Public Correspondence

**VOLCANO HEIGHTS
CONCEPTUAL DRAINAGE COMPILATION PLAN**

Volcano Height Sector Plan: Character Zones

Exhibit 11, The Road Network

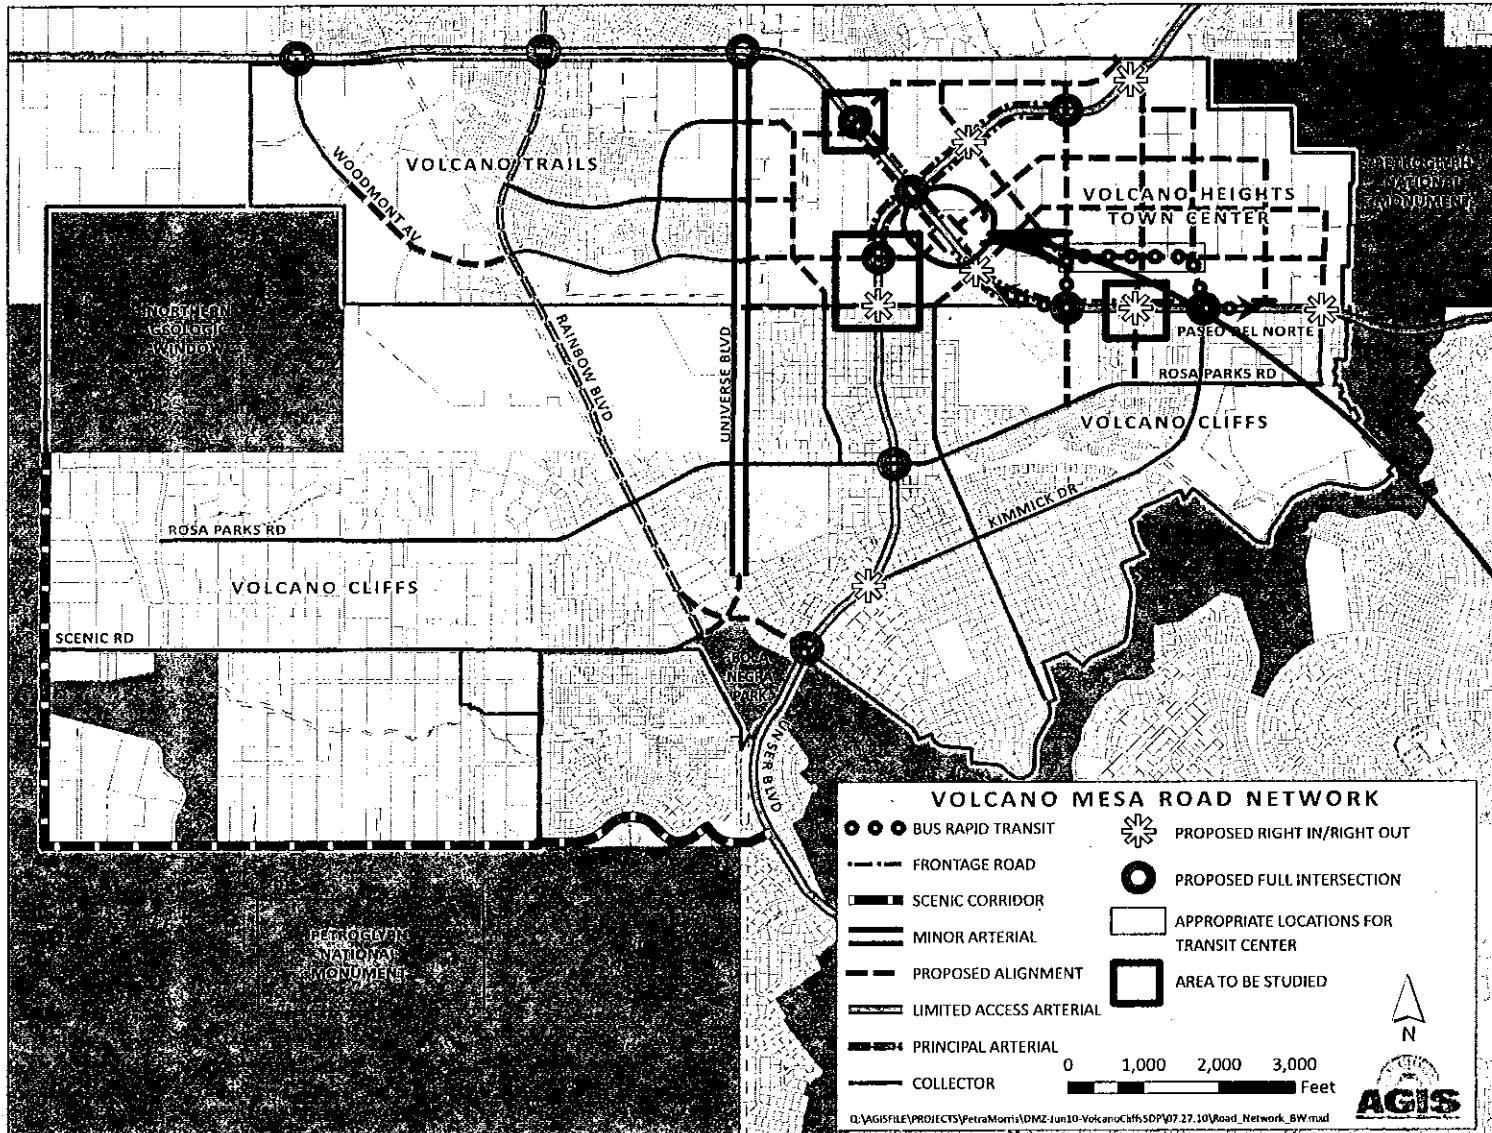
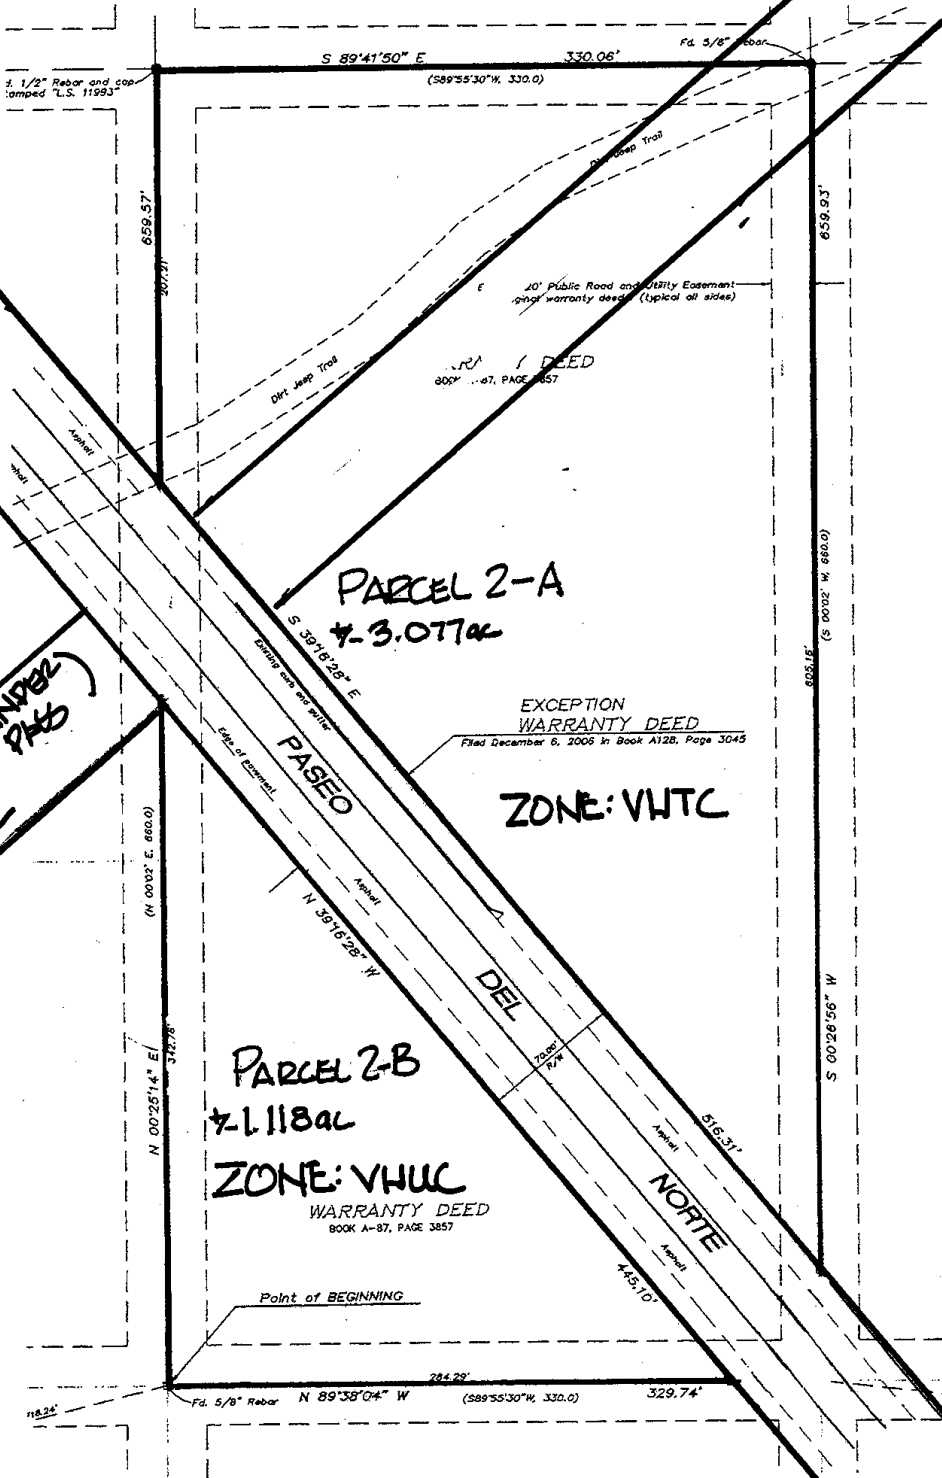
The current plan appears to call for an overpass located on our property. My questions are:

- 1) Does the plan call for an overpass or underpass at the identified location ?
- 2) If yes, who is responsible for building the overpass? I would assume a bridge over Paseo Del Norte would be a public improvement responsibility.

OVERPASS?

Until we know more, the answers to your questions below are:

- 1) No, the 2010 draft plan doesn't show an under or an overpass per se, but the road network is being revised with the new draft version anyway, so we still need to know more about it.
- 2) Roads will be largely the responsibility of the developers in this area, even when it's Paseo. Unser is a good example, as new segments have been paid for by the SAD for Cliffs or the subdivisions.

Character Zone Map

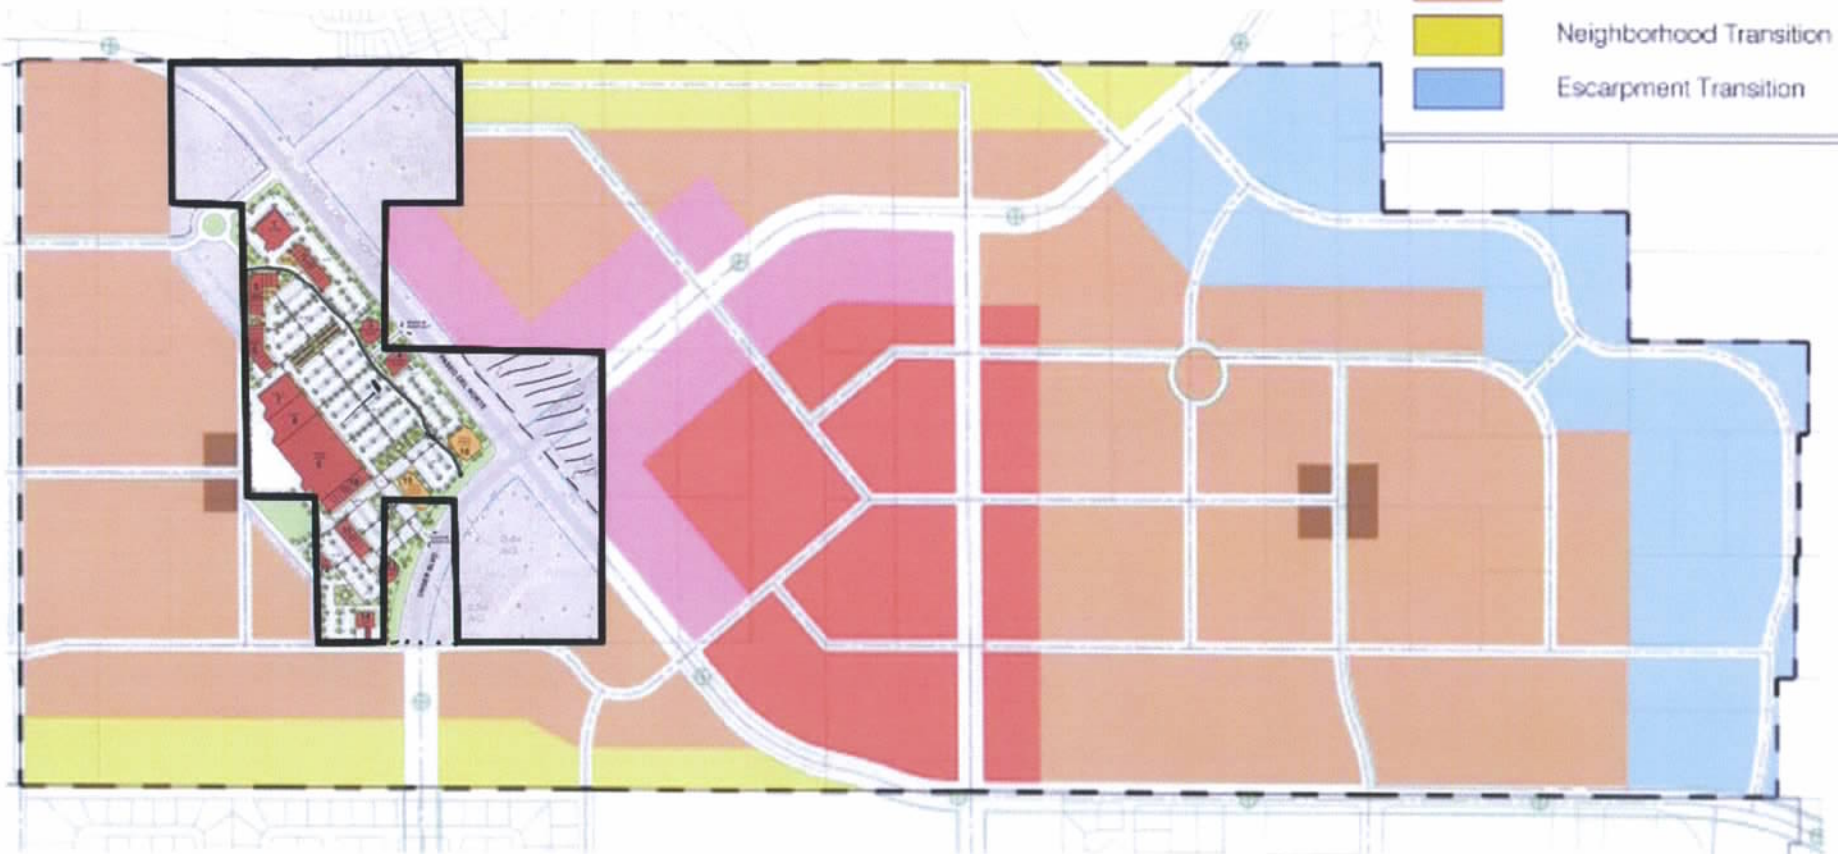
Page 12 Blue zone, Escarpment Transition, for the land in the north-east of the rectangle on Unser to Paradise (See page 4 and 14) is incorrect. This area adjoins platted land to the north that has been excluded from the drawing. This land has already been zoned for big box development and other projects. There is not escarpment there! I want all maps to go north to Paradise and show the entitlements already granted!
